PLAN SHOWING PROPOSED BUILDING TO BE

BUILT ON PLOT NO 58/1 J. L. 6.

JAIL QUARTER

Re: Plot No 58, J.G.B. Jail QuarterWith reference to your letter of 17th inst the plans have been modified as follows:—

GROUND PLAN

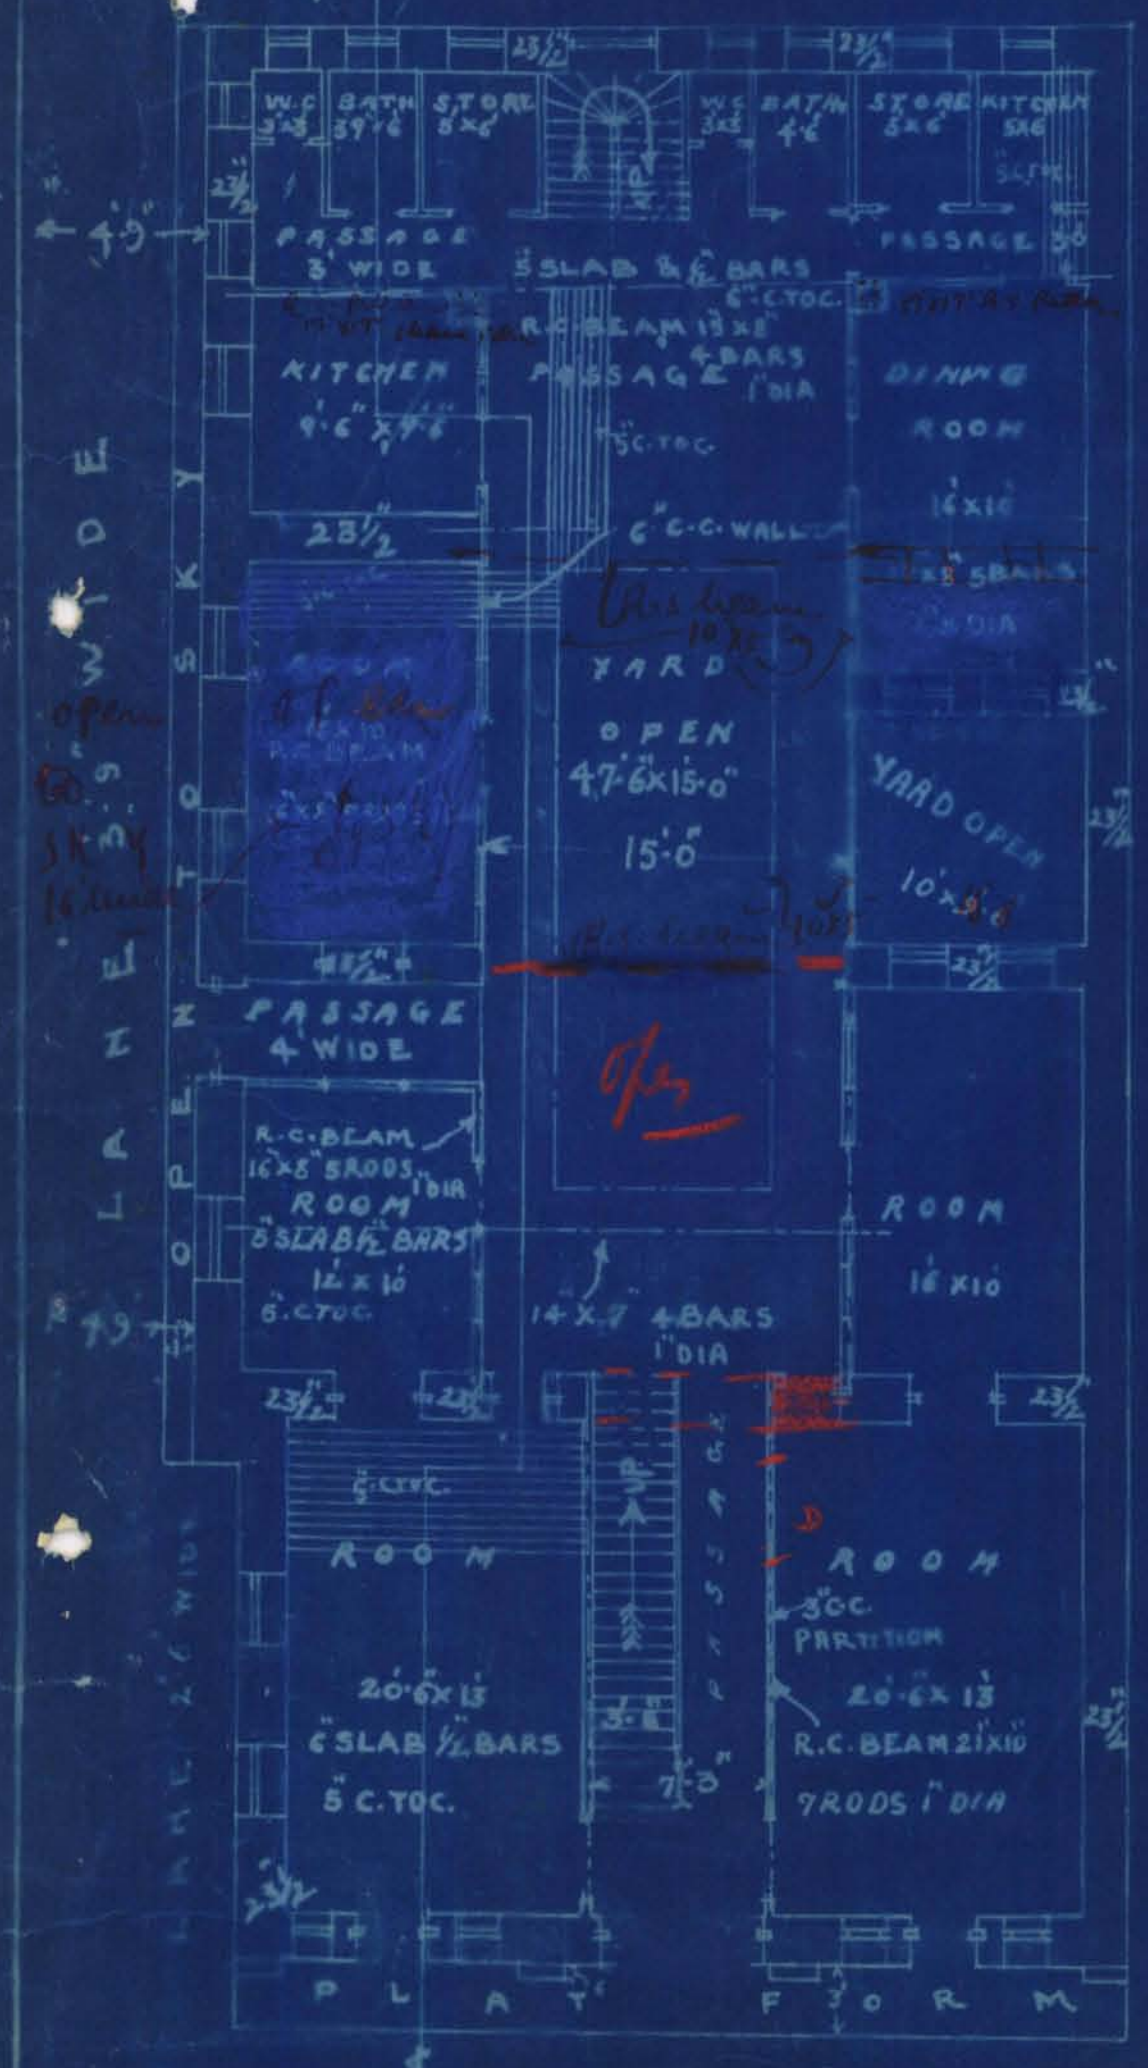
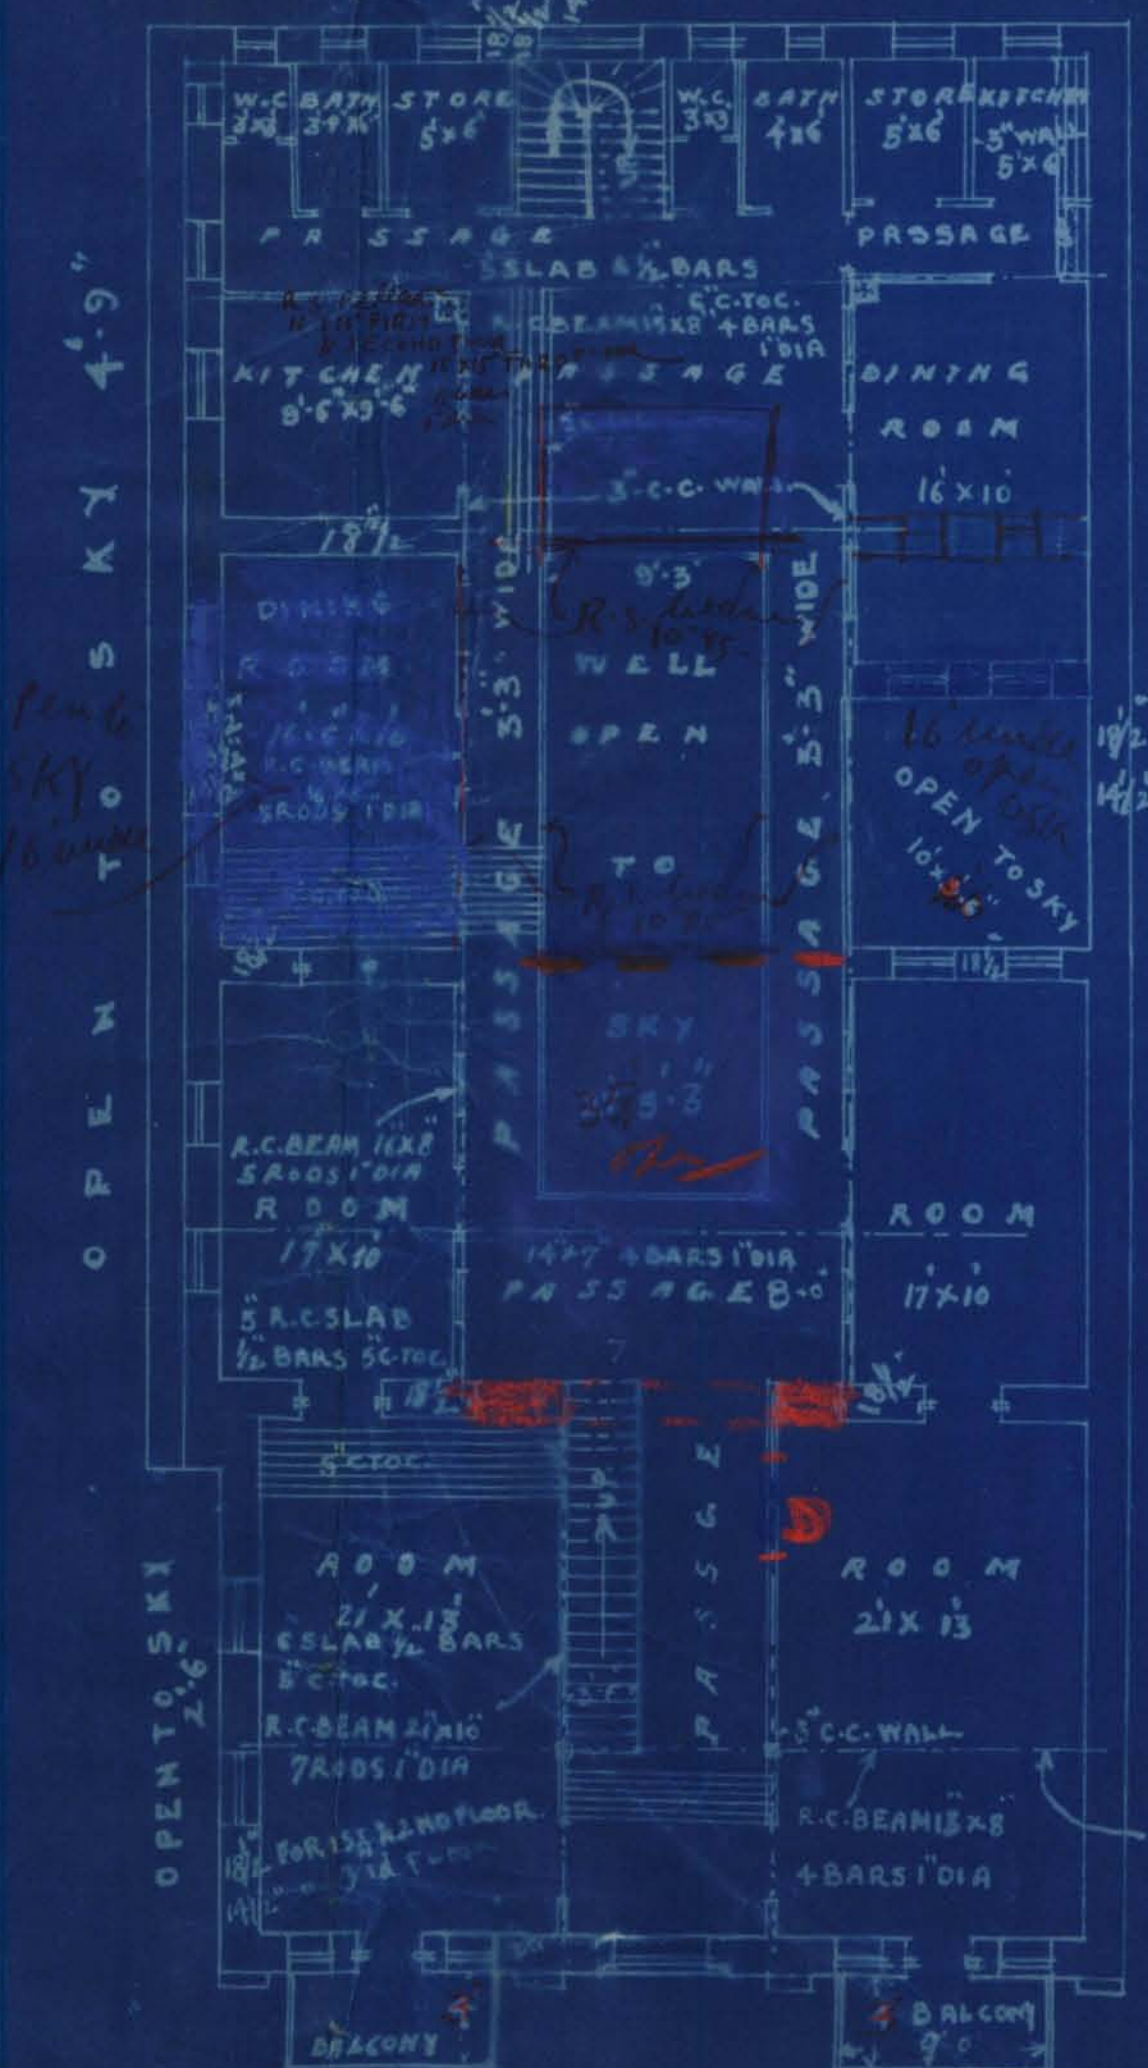
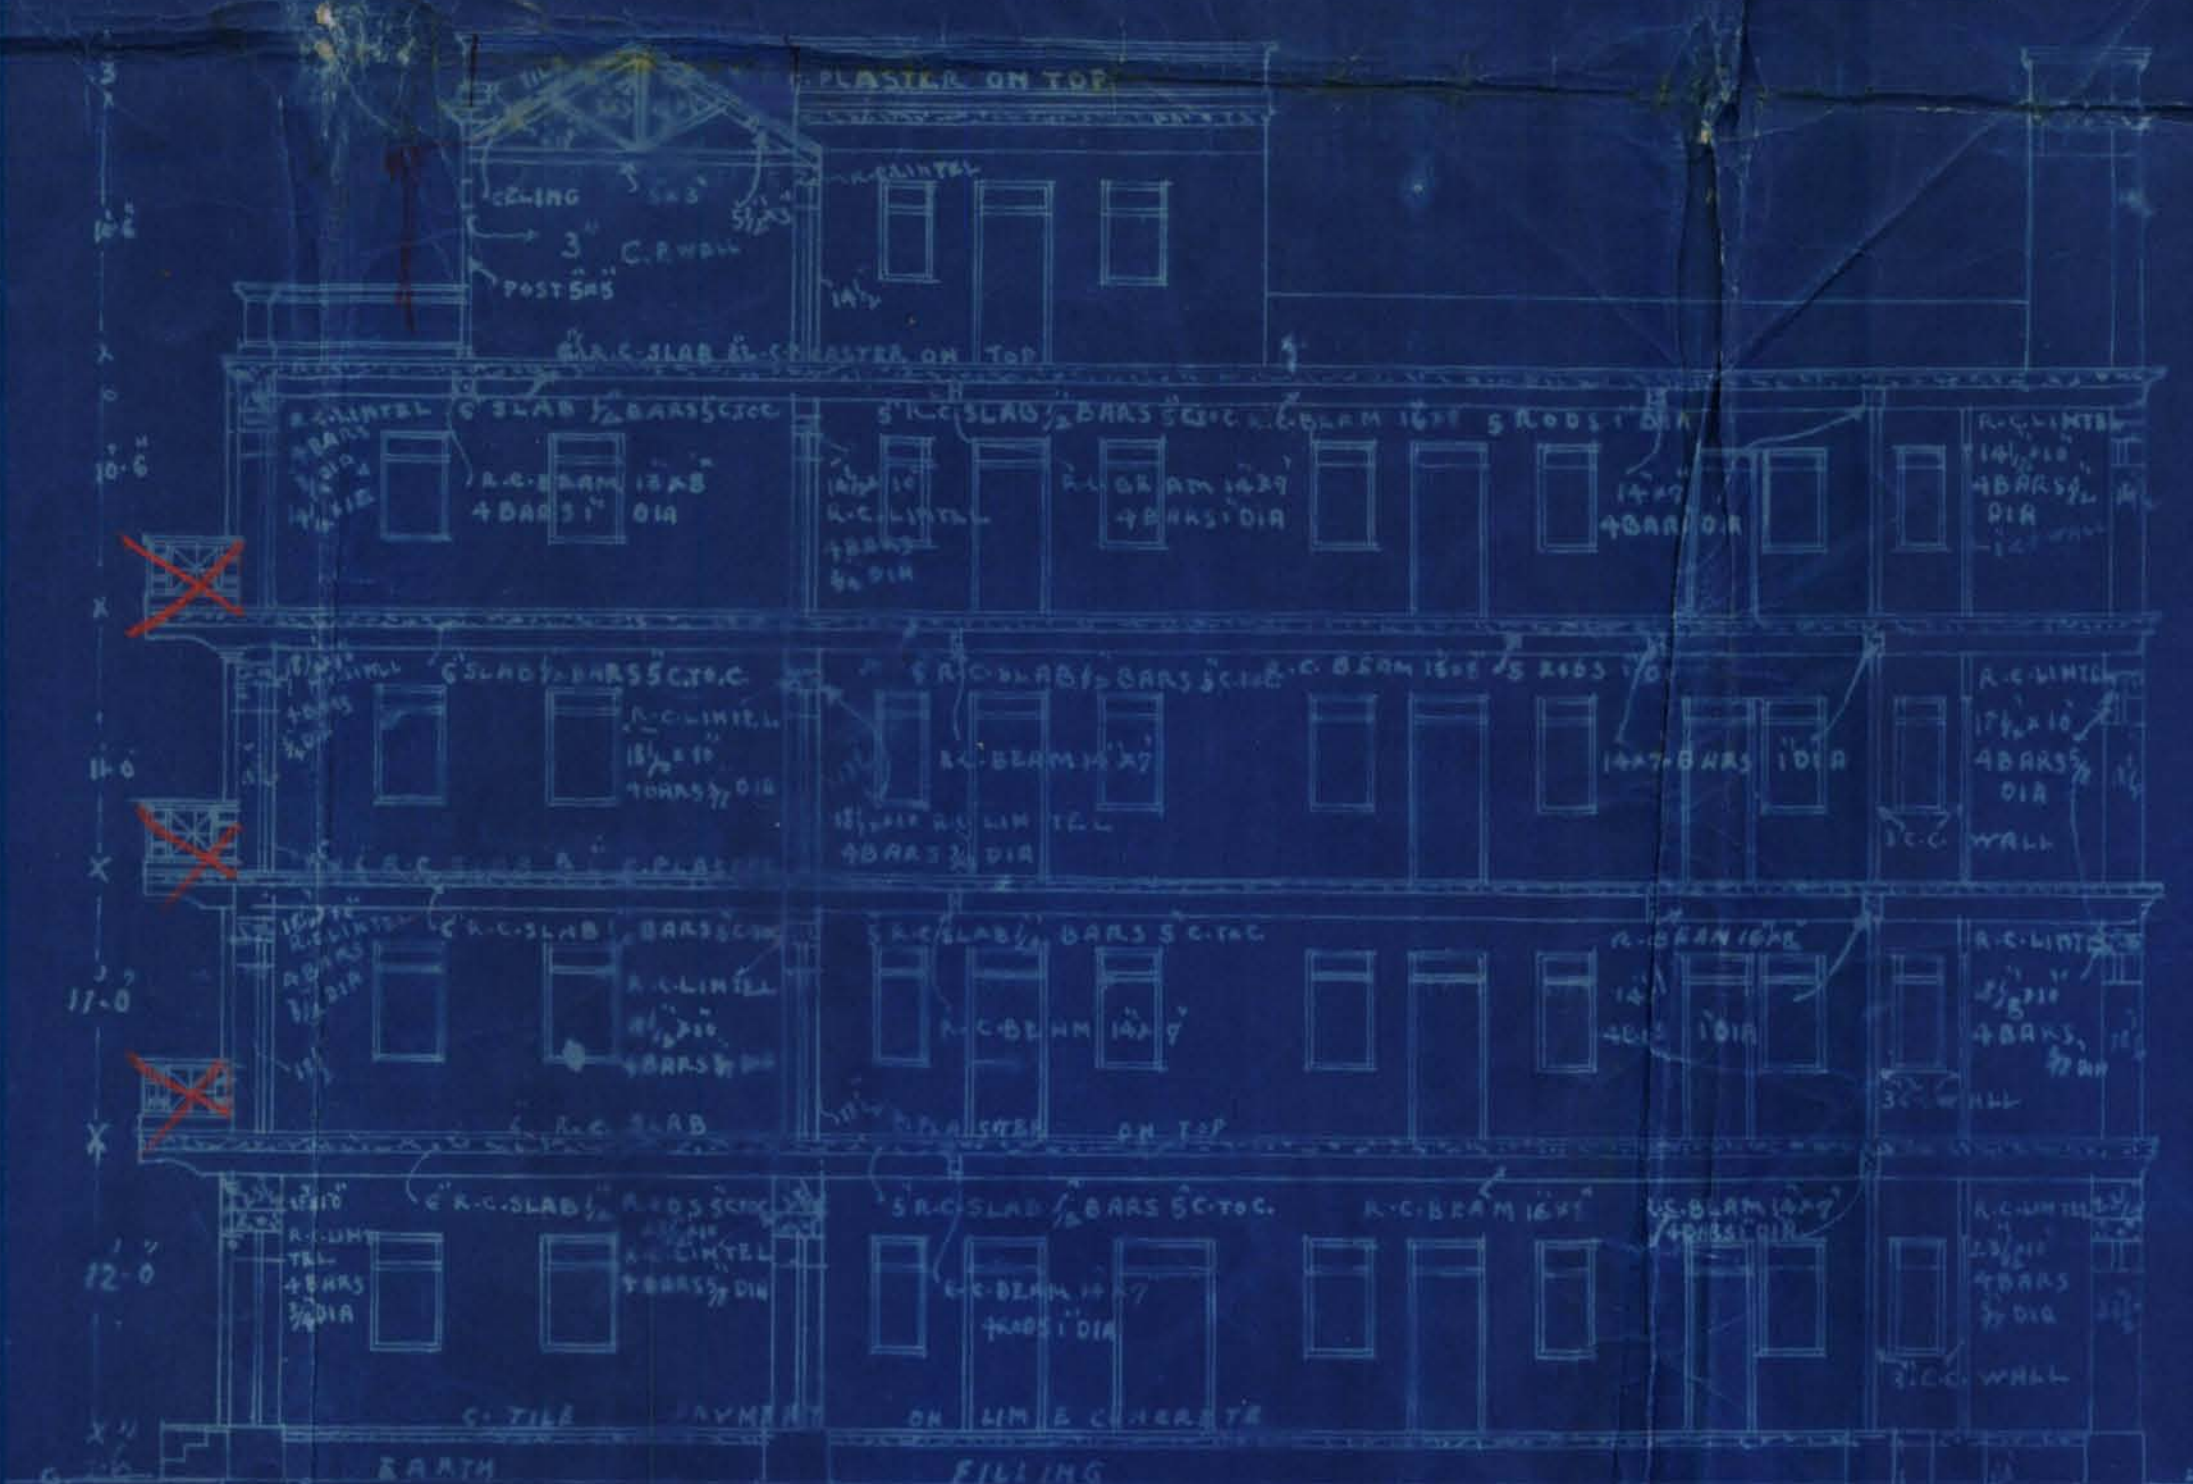
- (1) The building will be dark. Space ^{to open to sky} must be 16' wide instead of 9'-3" which is much less for 55' high building free from obstruction.
- (2) Beam arrangement for sanitary block must be shown. Beam C must rest on wall at the east end.
- (3) Beam A in front rooms is not shown in section.
- (4) Beam under the slab ^{shown} in the sectional view of front rooms is not clear. That must be drawn distinct. It shows the 2 1/2" x 10" beam coming over the 3" partition wall.
- (5) Balcony must not project more than 3 ft.
- (6) The design must be altered to a shape.
- (7) 3" external walls cannot be allowed.
- (8)
- (9)

- (1) Top Ceiling may not be allowed
- (2) Space open to sky must be ^{16' 2 1/2} ~~14~~ feet wide instead of 9' 3" which is much less for 55' high building, free from obstructions
- (3) no beams ^{are} provided to carry ^{Cement} partition walls of the Sanitary conveniences
- (4) beam A in front rooms is not shown in Section
- (5) Beam under the slab shown in a sectional view of front rooms is not clear - That seems to be incorrect or unnecessary must be drawn

Ho's objection, BS (2), beam arrangement for
Sawing block must be shown, Beam C must
rest on Wall at the E end, BS 2 to 4 & 5
balcony must not project more than 3'
The design must be altered to E. Shape.
3" external Walls cannot be allowed

- (1) Space open to sky is made 16' wide in
-stead of 9' 3".
- (2) Beam arrangement for sanitary
block is shown on plan.
- (3) Beam C rests on wall at East end.
- (4) Beam A is shown in section.
- (5) The beams 2" x 10" are meant to hold the
weight of slab as well as partition & so
are shown below partition.
- (6) Balconies are made 8' wide.
- (7) The design naturally becomes E shape
by increasing middle open space.
- (8) 3" external walls on top floor have been
covered by a verandah 3' wide.
